Item Name: Crosstube Aft

Dart Aerospace I	Ltd
-------------------------	-----

DART AEROSPACE LTD	Work Order:	85370
Description: Crosstube High Aft (412)	Part Number:	D412-664-203
Inspection Dwg: D412-664-243 Rev: E		Page 1 of 1

DRAWING NO. D412-664-243	THLE	DE 4000//	REV. E	DART AEROSPACE LTD		SHEET NO.	SCALE
DRAWN	CROSSTU	· · · · · · · · · · · · · · · · · · ·	12 HI AF I)	ENGINEERING ORDER	7	SHEET 1 OF 1	NTS
	47	CHECKED	<u> </u>	MFG. APPR.	APPROVED MY	DE APPR.	
DATE 11	09.07	DATE	11.05.19	DATE ((.09.19	DATE 11.09.19	DATE 11.09.19

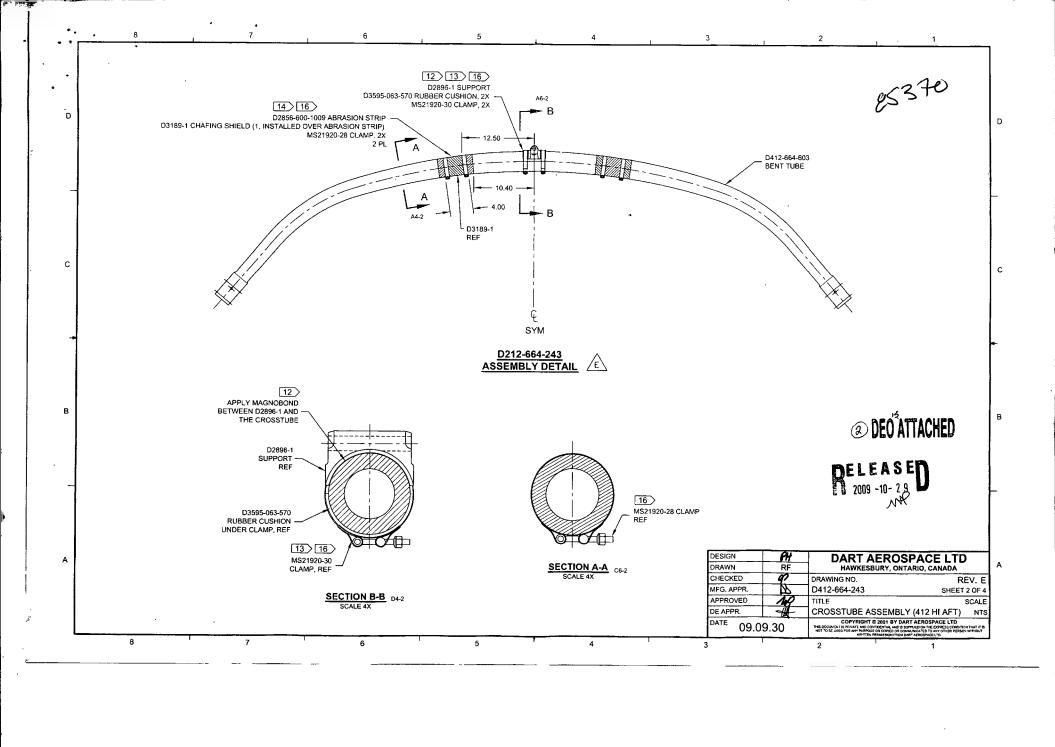
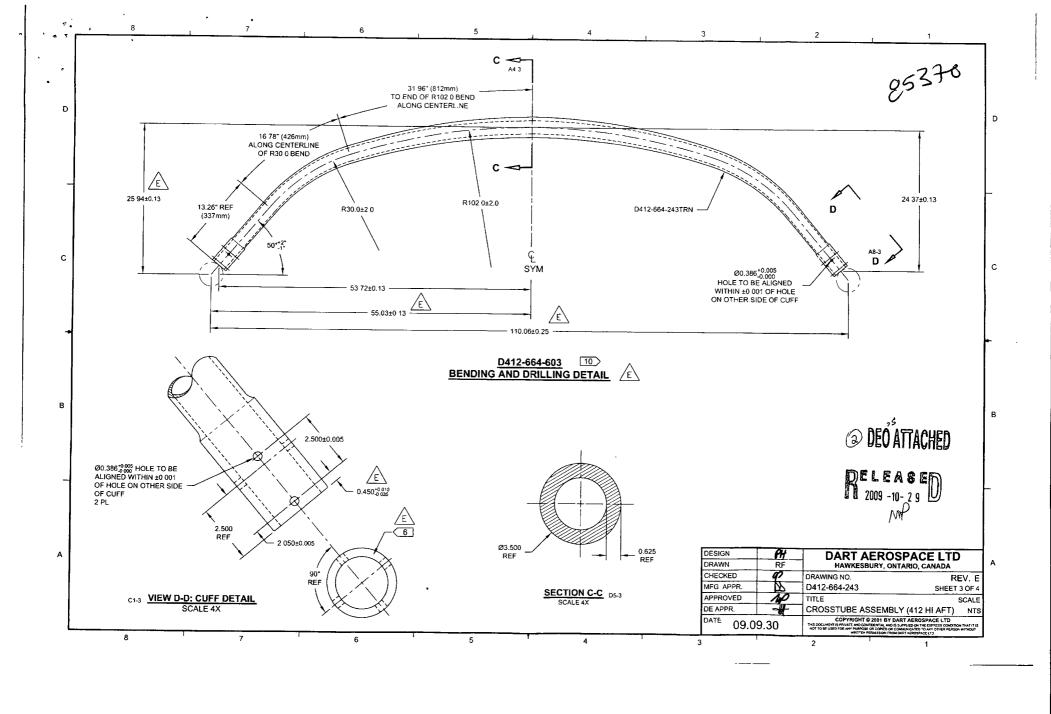
ε	REORG TO CUF PAR 08- C8-3 &	REFORMAT/REVISE GENERAL NOTES: REORGANIZED VIEWS AND REFORMATTED DRAWING TO CURRENT STANDARDS; RELOCATED FLAG #6 PER PAR 09-046 (ZN 46-3), ADD TOLERANCE (ZN 86-3, C4-3, C4-3, C5-3); MOVED TURNING DETAIL & UPDATED TOLERANCE TO SHEET 4.						
D	REMO	REMOVE D2732-058, CHANGE TO D3595-063-570 PH 07 03.09						
С		VE D2856-600 OBOND 6398.	мв	06.10.27				
В	ADD HOLES FOR COMPATABILITY WITH BHT/AA SKIDTUBES				05.02.04			
Α	NEW ISSUE				01.10.17			
REV.	DESCRIPTION				DATE			
DESIGN		PH	DART AEROSP	ACE	LTD			
DRAWN		RF	HAWKESBURY, ONTARIO, CANADA					
CHECKED P		P	DRAWING NO.		REV. E			
MFG. APPR.		77	D412-664-243 SHEET 1					
APPROVED 10		10	TITLE SCA					
DE APP	R.	-#	CROSSTUBE ASSEMBLY (412 HI AFT) NT					
DATE 09.09.30			COPYRIGHT © 2001 BY DART AEROSPACE LTD THIS DOCUMENT 5 PRIVATE AND CONTRINITION AND IS JUPY 50 ON THE EXPRESS CONDITION THAT IT IS NOT TO BE USED FOR ANY PURPOSE ON COMPRISE ONE CONDITIONATED TO ANY OTHER PRISE ON WITHOUT

* DRAWING N D412-664		REV. E BE ASSEMBLY (412 HI AFT)	DART AEROSPACE LTD ENGINEERING ORDER		SHEET NO.	SCALE
DŘAWN	<u> </u>	CHECKED M	MFG. APPR.	APPROVED //	SHEET 1 OF 2 DE APPR.	NTS
DATE	11.03.31	DATE 11/03.31	DATE #1.03.31	DATE 11/03:31	DATE 11-03.31

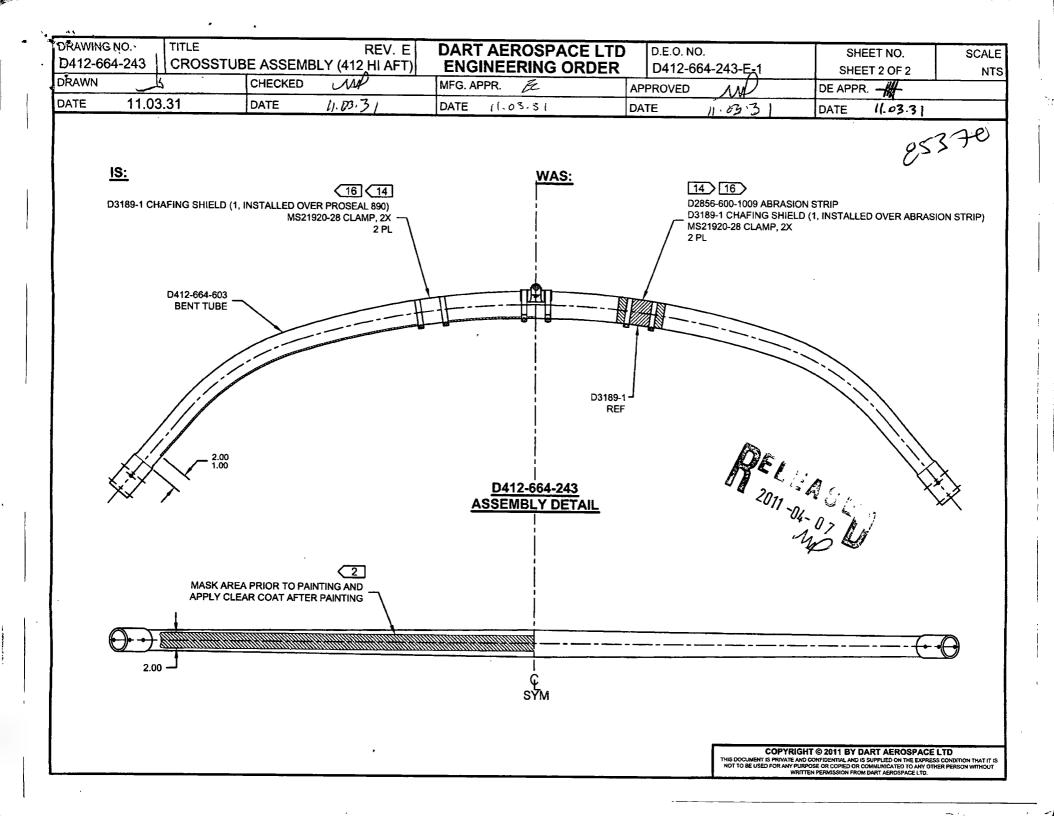
PURPOSE:

REMOVED ABRASION STRIP IN FAVOR OF A THIN LAYER OF PROSEAL 890.

PARTS LIST IS AMENDED AS FOLLOWS:

NOTES 2 AND 14, SHEET 1 ARE AMENDED AS FOLLOWS:

IS:

2) FINISH: CHEMICAL CONVERSION COAT PER DART QSI 005 4.1 PRIME INSIDE AND OUTSIDE PER DART QSI 005 4.2

MASK UNDERSIDE OF CROSSTUBE AS SHOWN (HATCHED AREA)

PAINT OUTSIDE PER DART QSI 005 4.2

AFTER PAINTING, APPLY CLEAR COAT ON HATCHED AREA

14) APPLY A THIN COAT OF PROSEAL 890 ON INSIDE CONCAVE SURFACE OF D3189-1 CHAFING SHIELD AND LET CURE PER MANUFACTURER'S INSTRUCTIONS. INSTALL PROSEALED D3189-1 CHAFING SHIELD ONTO CROSSTUBE BY APPLYING A THIN COAT OF PROSEAL 890 ONTO CROSSTUBE. BE SURE TO ELIMINATE ANY AIR GAPS.
